FUEL- FILLER / CHARGE LID OPENS UNINTENTIONALLY WHEN UNLOCKING FRONT DOORS

Bulletin No.: 09-022/22

Last Issued : 06/14/2022

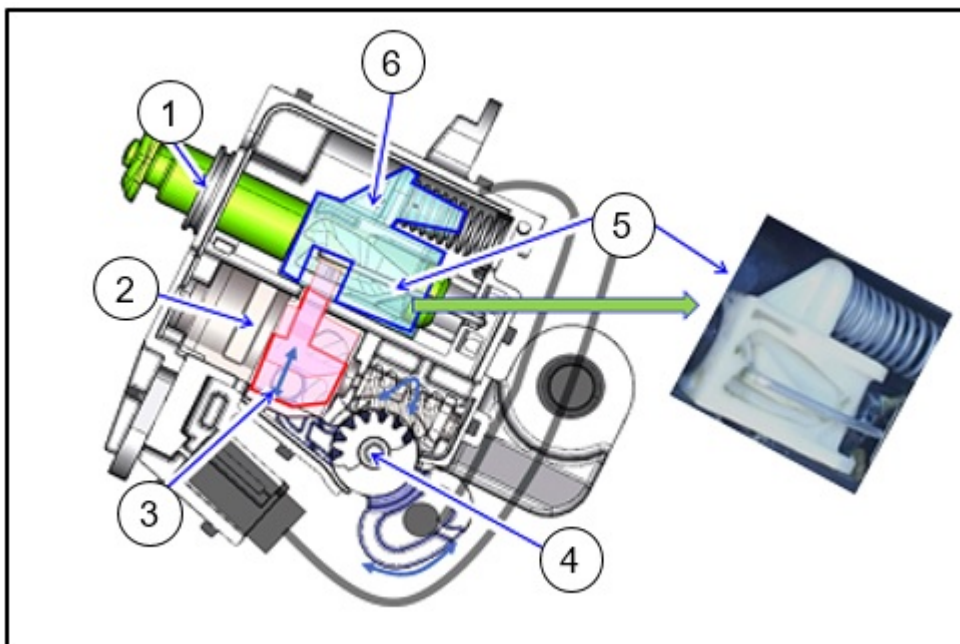
Some vehicles may exhibit the fuel-filler or charge lid opening unintentionally when unlocking the front doors using the door lock switch, the touch sensor on the outer door handle, or the remote transmitter.

This is caused by a mechanical issue at the actuator of the fuel-filler/charge lid (when the fuel filler/charge lid is pushed hard, the guide pin in the actuator comes off).

- (1) Lifter pin
- (2) Motor
- (3) Lock lever
- (4) Helical gear
- (5) Guide pin
- (6) Cam

To eliminate this concern, the durability of the guide pin in the actuator has been improved.
